DECISION NOTICE UNDER S 335 SUSTAINABLE PLANNING ACT 2009: DEVELOPMENT APPLICATION FOR ANDREASSEN ROAD, CRAIGLIE

PROPOSAL House building envelope

Drawing or Document	Reference	Date
Proposed Building Pads	RECS 42-2013 C01 Issue B	11 September 2013
Plan		
Sections	RECS 42-2013 C02-2 Issue A	11 September 2013

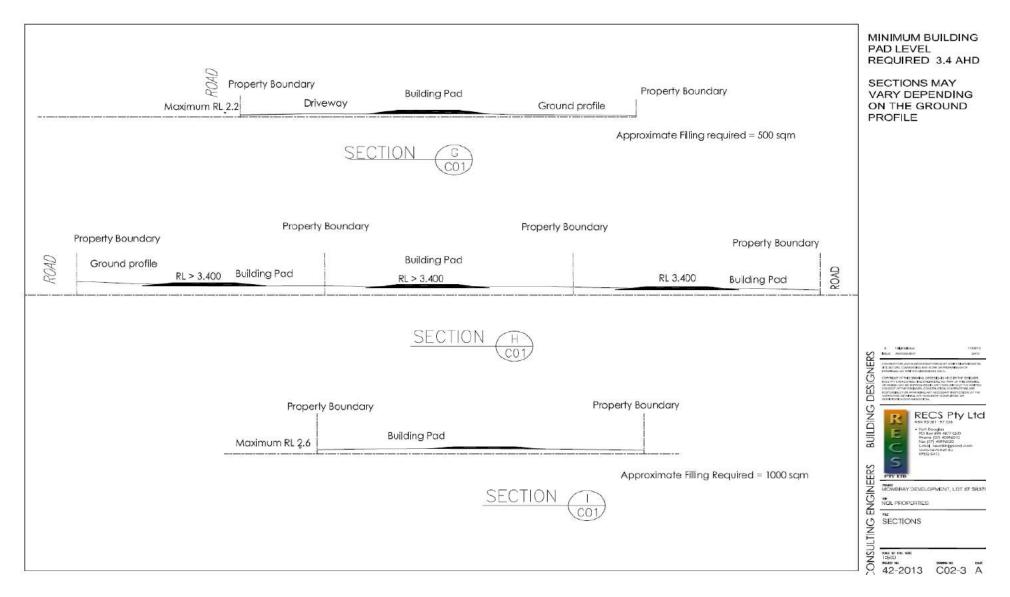
- 4. The proposed building pad to accommodate the future; House, wastewater system and ancillary infrastructure must include the following:
 - A minimum regular-shaped area of greater than 800m² of land above 3.4m AHD;

5. The proposed driveway to the building pad from the unnamed internal access road, as shown on the Building Pad Plan 42-2013 C01 Issue B prepared by RECS Pty Ltd and dated 11 September 2013, must be constructed at a level that provides immunity from a Q10 ARI flood event. The construction of the driveway must not impede overland flows in a manner that creates a direct or cumulative impact on neighbouring or downstream properties. In this context, the Registered Professional Engineer of Queensland is required to provide a plan of any proposed culvert works associated with the driveway that demonstrate the free movement of stormwater across the site.

- The proposed earthworks on the site require an application for Operational Works. The concept for filling as detailed on Proposed Building Pad Plan 42-2013 C01 Issue B prepared by RECS Pty Ltd and dated 11 September 2013, will be required to be submitted in addition to the following:
 - a. Details identifying the specific movement of fill material around the site. This is also to include detail on the total volume of material proposed to be brought onto the site and management of this;
 - b. Details on the stockpiling and transportation of fill material; and
 - c. Details identifying that all earthworks will be compliant with the requirements of relevant drainage conditions contained in Conditions 4 and 5 above.
